Thor Motor Coach Technical Service Bulletin 10-010

TSB # **TSB 10-010**
Description/Title: **2011 23U Heat Shield**
Affected Product Line(s): **Four Winds 23U Class C**

Service Campaign # : **RC000029**

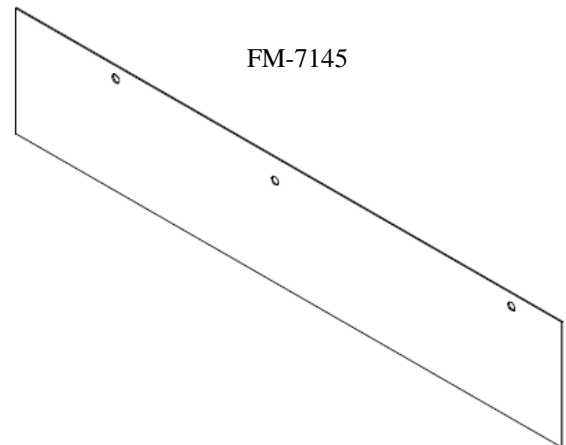
The engine exhaust runs down inside of the frame rail, behind LP tank, and does not have the proper heat shield in place.

The heat shield will be placed behind the LP tank, on the outside of the frame rail, and attached using three existing holes in the frame. The Heat shield should hang down from the frame rail when in proper position.
